**HVAC Replacement for
Summit Drive Elementary School
Greenville County School District**

Solicitation No: **124-33-9-29**

Addendum No. 2

DATE: October 12, 2023

DESIGN	RAB	CHECKED	PEK
DATE	9-12-23	PROJECT NO.	221202
SHEET			
E-2

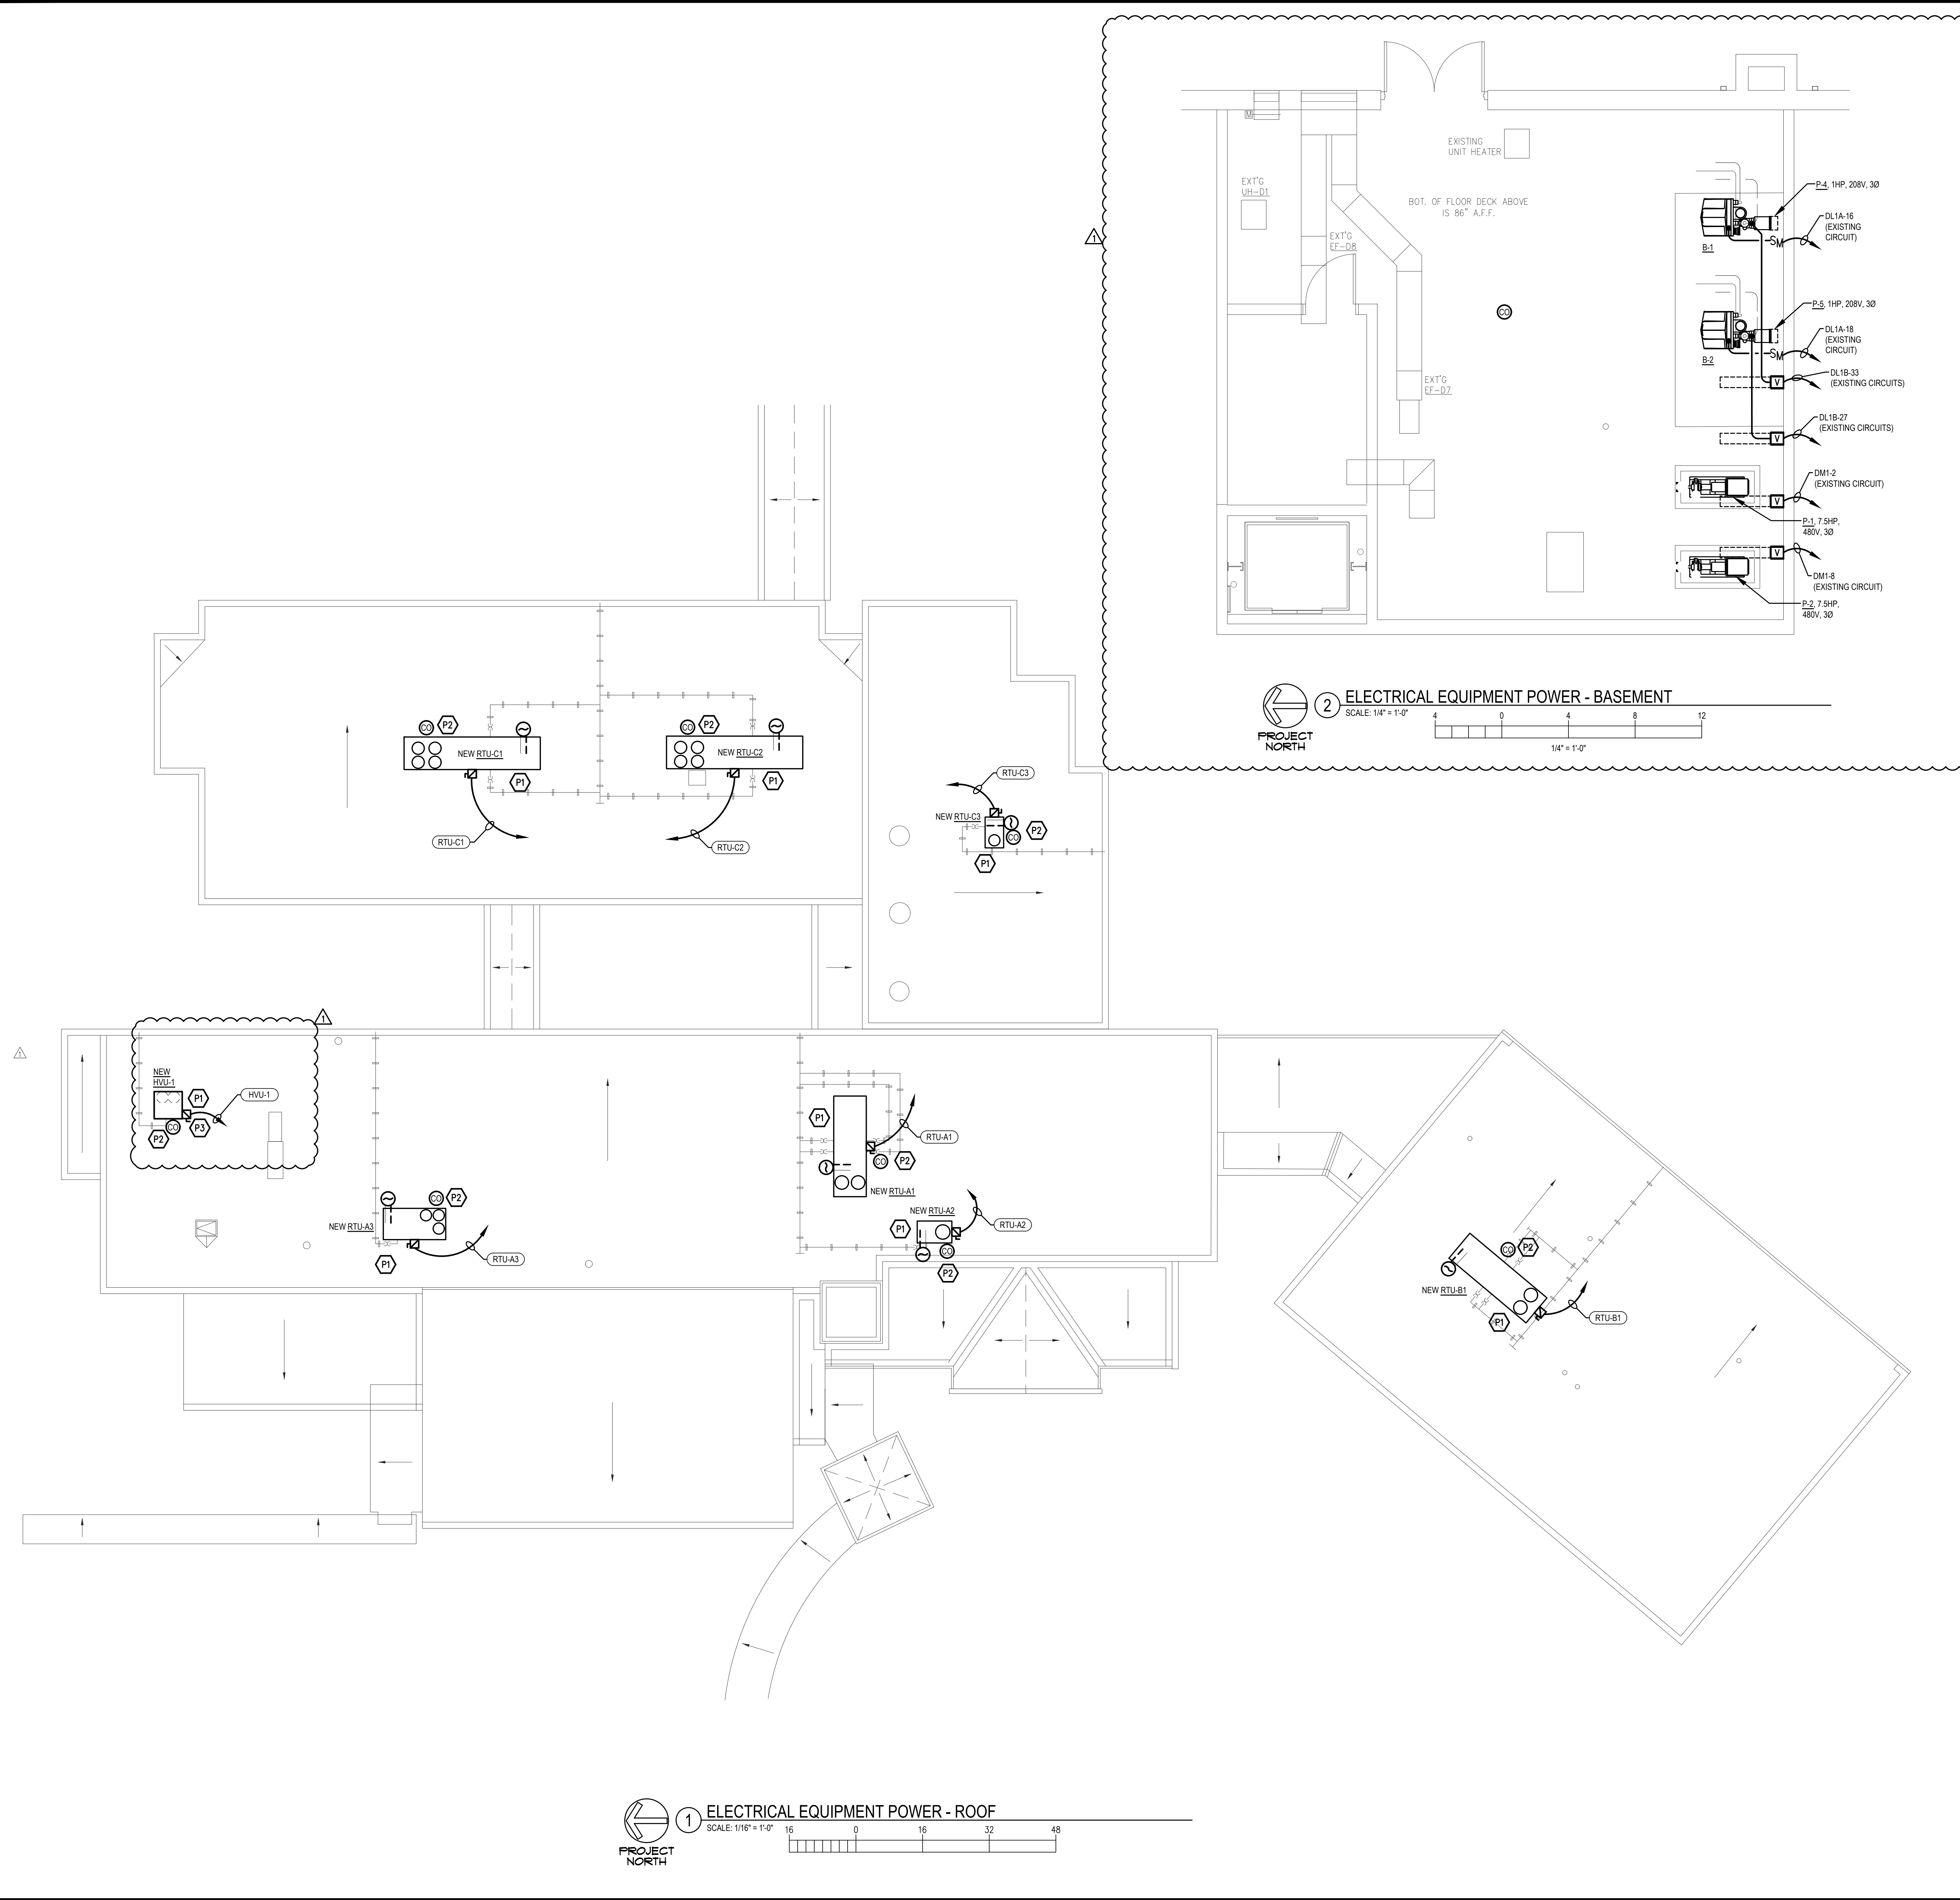
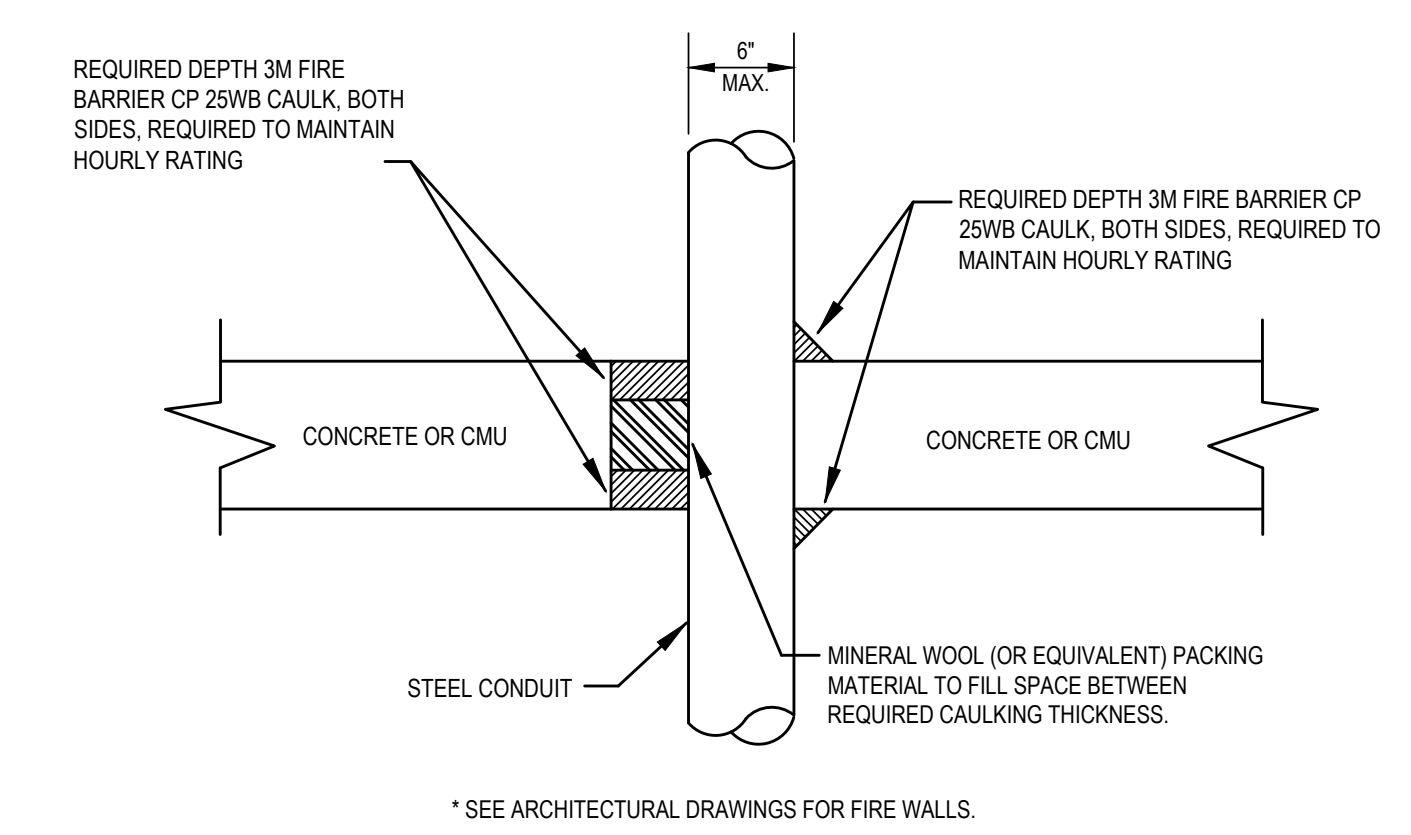
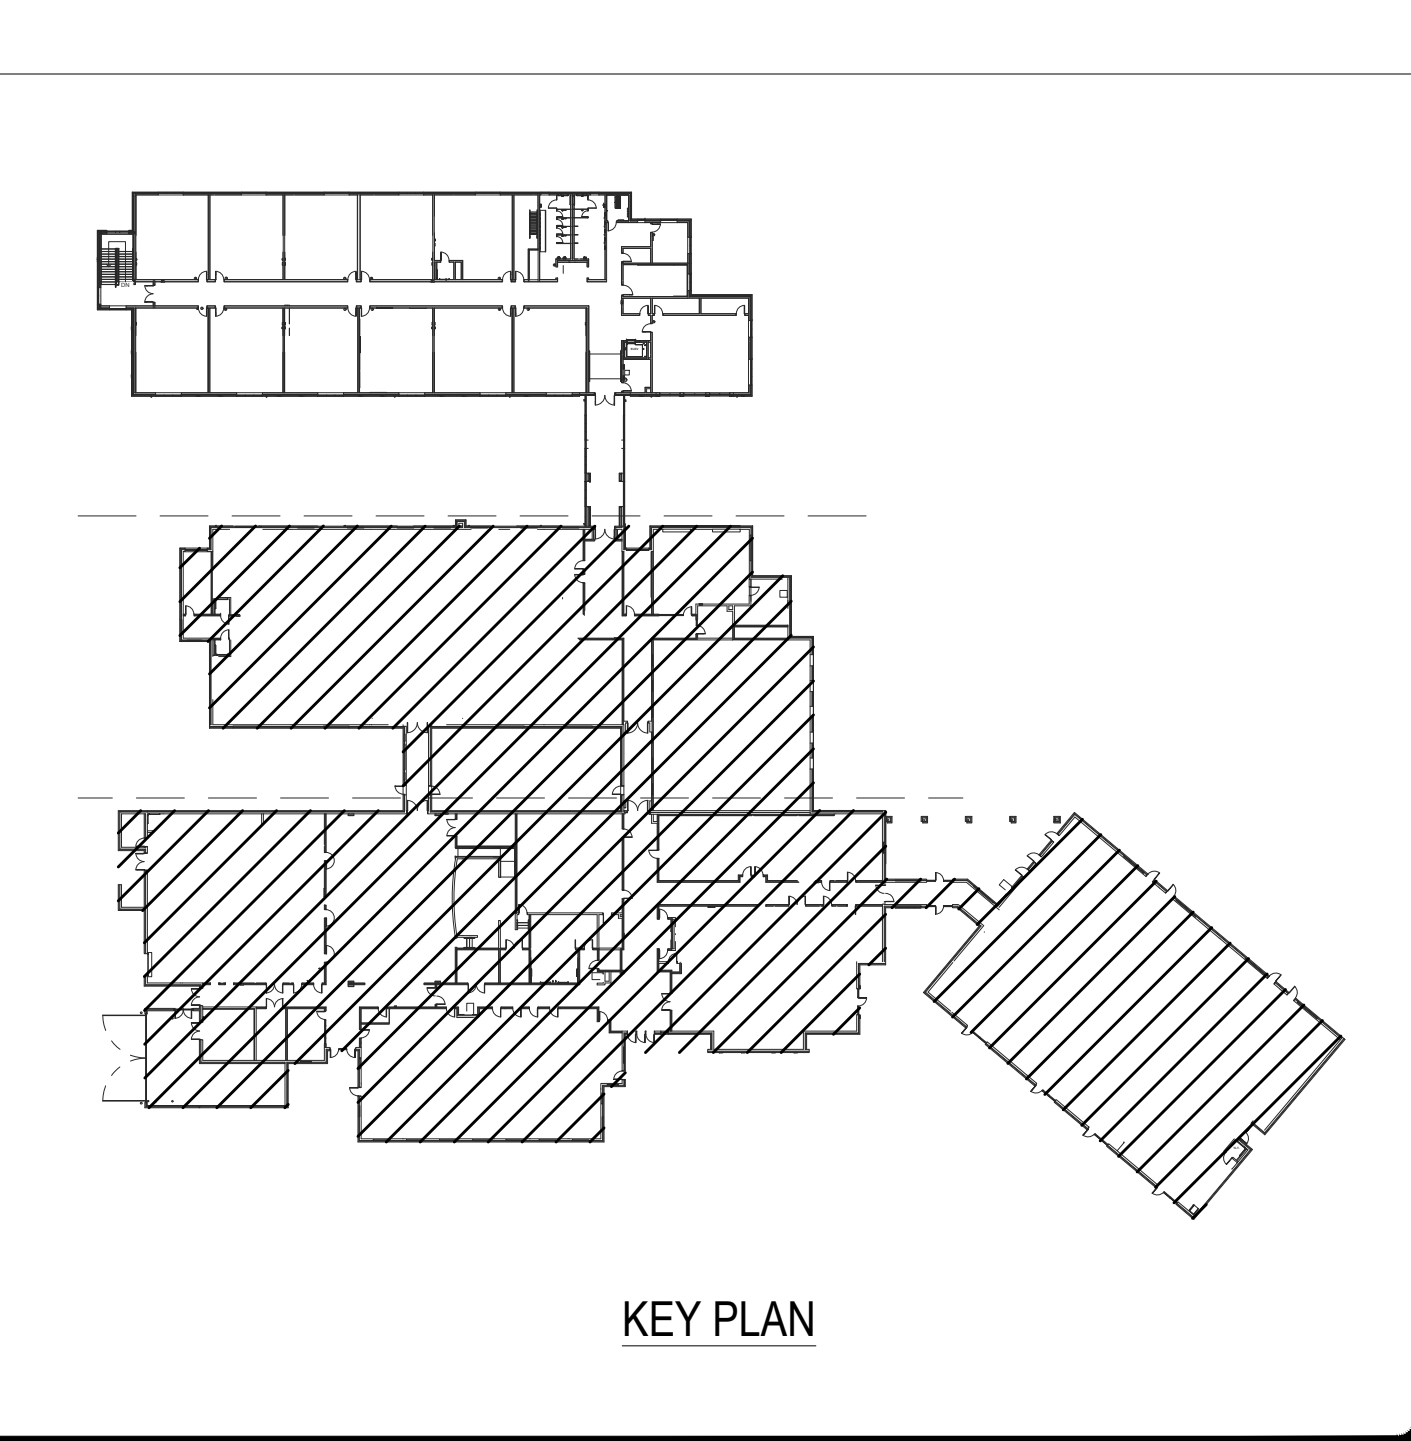
6. E-1, Electrical Legend, and Schedules, Added basement level plans and breaker for new Roof Mounted HVU-1 unit.
7. E-2, Electrical Overall Equipment Power Plan, Added power to new Roof Mounted HVU-1 unit. Added basement plan and power connections to replacement boilers and pumps.
